3.2 Surface Water Resources

**Figure 3.2-1: Pleasure Lake Dam
Inundation Area**

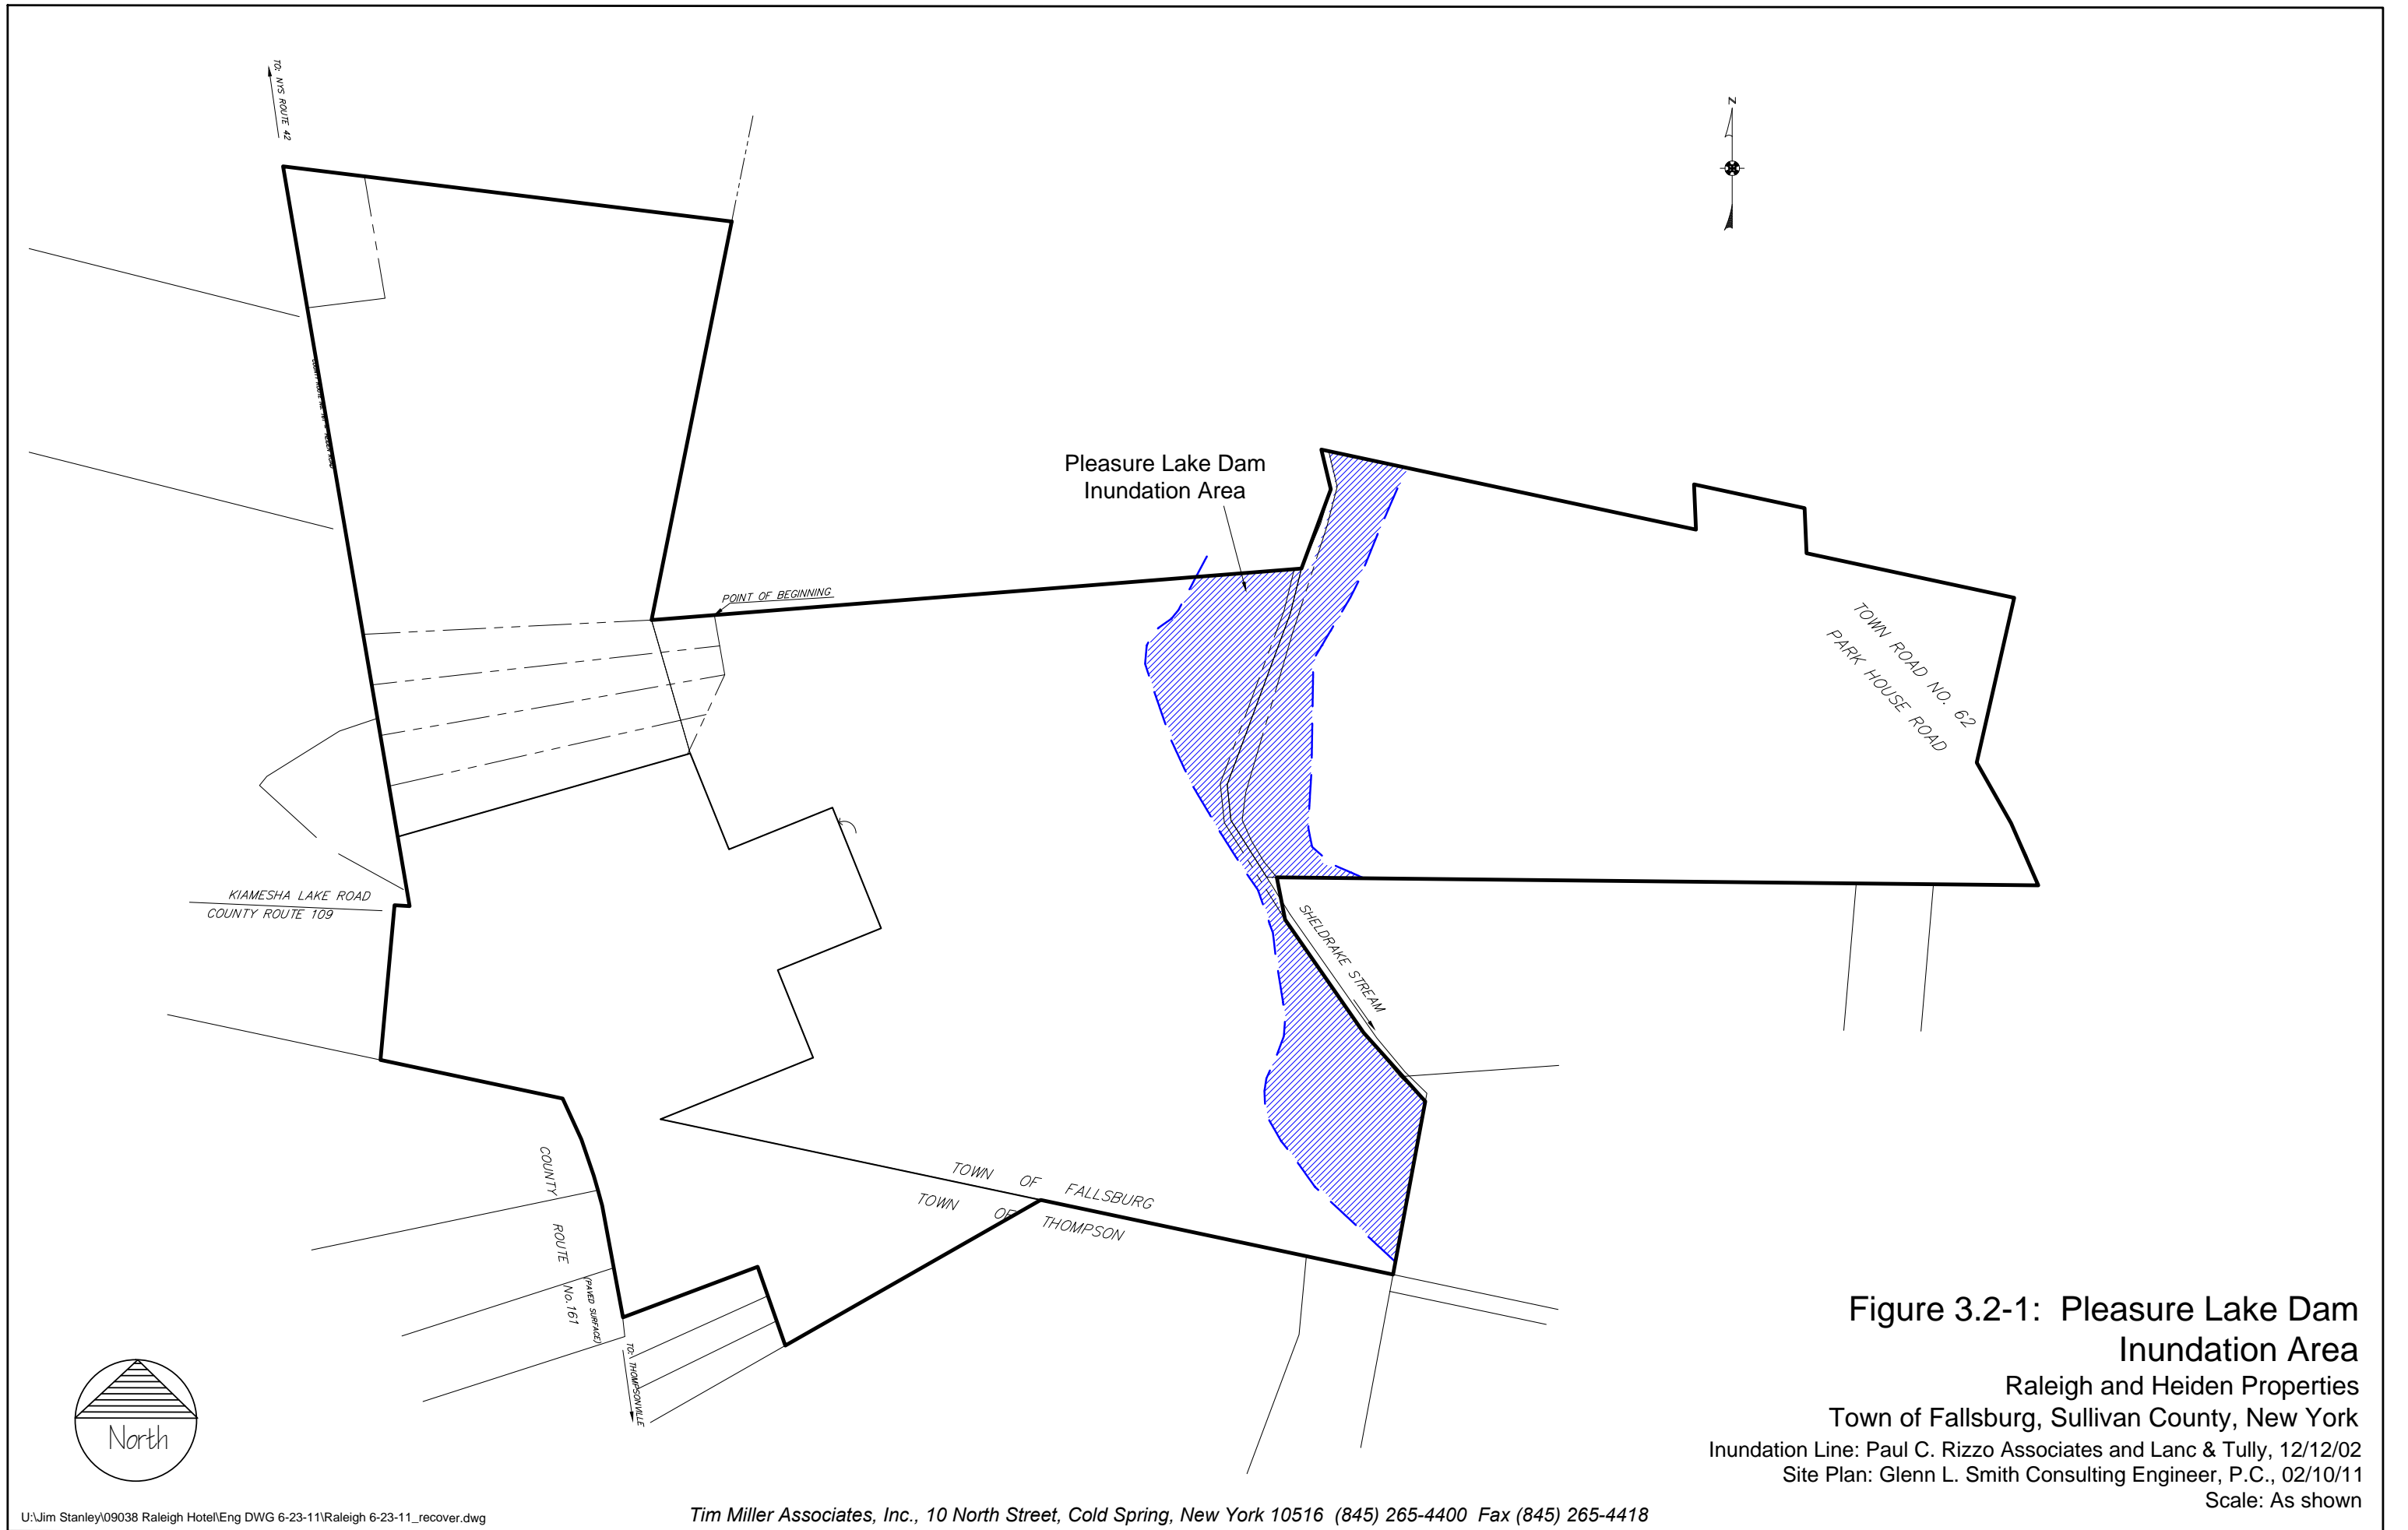
Comment 3.2-1 (Planning Board Meeting, November 10, 2011, Frank Stratton): The first comment particularly related to the Fallsburg Fishing and Boating Club is that early on in the process we received a commitment from the developer that they would remain outside the dam inundation zone. Essentially if there was a dam break, which we hope never will be, but within that zone there are certain levels of responsibilities that the Fallsburg Fishing and Boating Club have in terms of notification and just general responsibility. And right now, that scope is relatively small but as we move to a project of this size, this scope, this many people, in an area where there is a potential for danger, it increases the cost to the Fallsburg Fishing and Boating Club, although the DEIS says there will be no cost change at all, we respectfully disagree and find that to be a statement that doesn't make sense. But we're pleased to see that the cluster authority proposal, I believe, keeps the structures out of the inundation zones other than, I believe, the water treatment plant. Is that right?

Comment 3.2-2 (Planning Board Meeting, November 10, 2011, James Creighton): Good. I know the ultimate proposal that the standard subdivision that if the town were not to go with the cluster, maintains a number of structures within that inundation zone and would create a significant hardship to the Fallsburg Fishing and Boating Club just on a notification scale but also in terms of if there ever was an emergency. They would probably be in a position where they would need a far greater notification project, something along the lines of but not as large as Indian Point would have, but we would need some kind of robo-call or siren system or something, if the standard subdivision were to be implemented. We do support the cluster authority proposal; it does make sense in terms of maintaining some of the view shed and allowing for a sensible development of the property.

Response 3.2-1: The water treatment plant is in excess of 800 feet outside the inundation zone.

Response 3.2-2: The cluster does allow for the placement of all residences and activity areas outside the inundation zone thereby providing greater safety for future residents.

Figure 3.2-2: Pleasure Lake Dam Inundation Area with Proposed Site Plan
 Raleigh and Heiden Properties
 Town of Fallsburg, Sullivan County, New York
 Inundation Line: Paul C. Rizzo Associates and Lanc & Tully, 12/12/02
 Site Plan: Glenn L. Smith Consulting Engineer, P.C., 02/10/11
 Scale: As shown

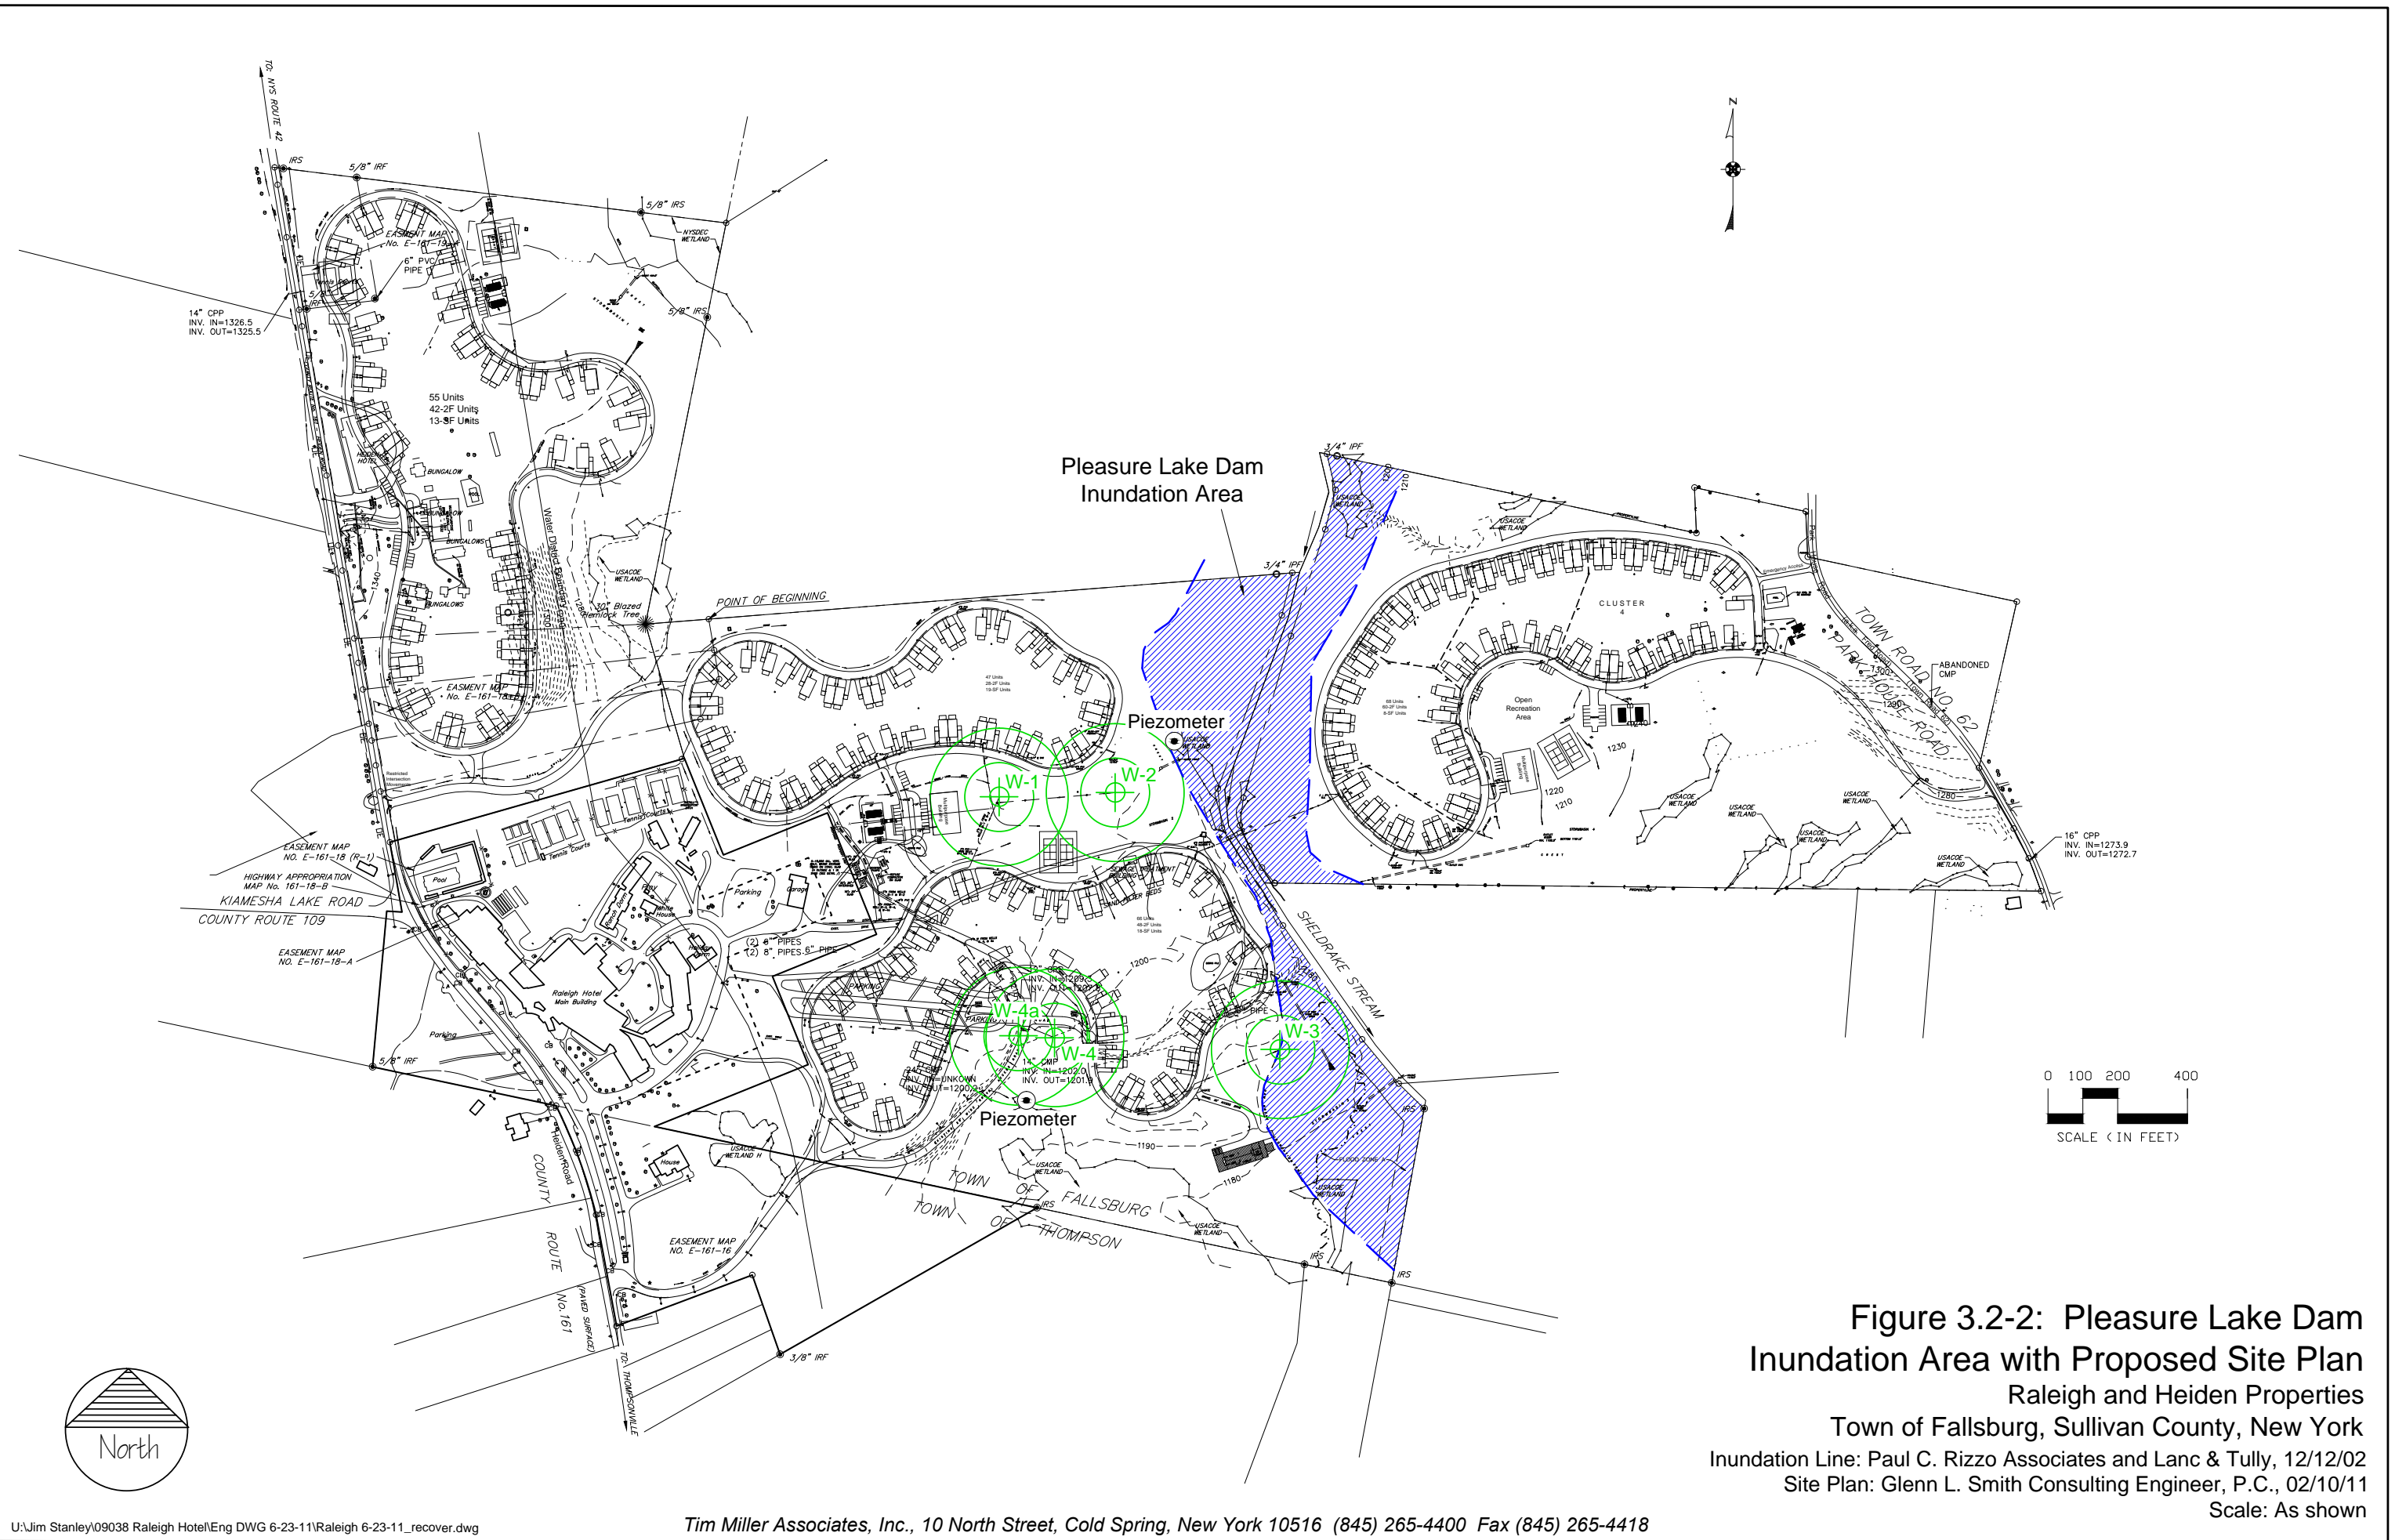
Comment 3.2-25 (Letter to Planning Board, December 10, 2011, Robert Pinckney): This area is also prone to flooding.

Response 3.2-25: All areas subject to flooding as identified by the dam inundation zone, and including the FEMA, 100-year flood zone have been illustrated on the site plans. No development of homes, roads and utilities is proposed within those areas.
